BCA MEMORANDUM

Project: Snowstream Apartments Thredbo

Subject: Proposed Deck Extension

Doc. No.: 2207 Memorandum

Figure 2- proposed deck extension

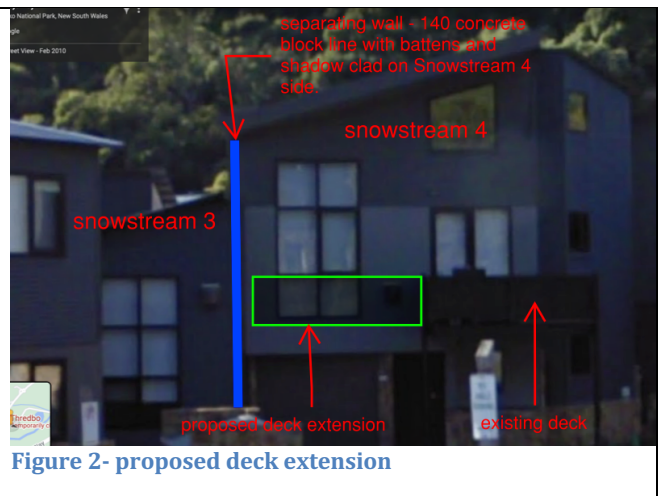
The two subject apartments share a common wall which extends the full height of Snowstream Apartment 3 and continues beyond the roof line for to the upper portion of the subject apartment snowstream 4 as can be seen in Figure 2 above.

The proposal to extend the balcony to the east towards the external wall of Snowstream 3 does not increase the risk of fire spread to or from the compliant separating wall if no modifications to the existing separating wall occur.

To ensure that any failure of the proposed balcony extension does not reduce the integrity of the separating wall any proposed extension must not connect to/or require structural support from the separating wall. The proposed balcony must be self-supporting and/or supported by the structure of Snowstream 4.
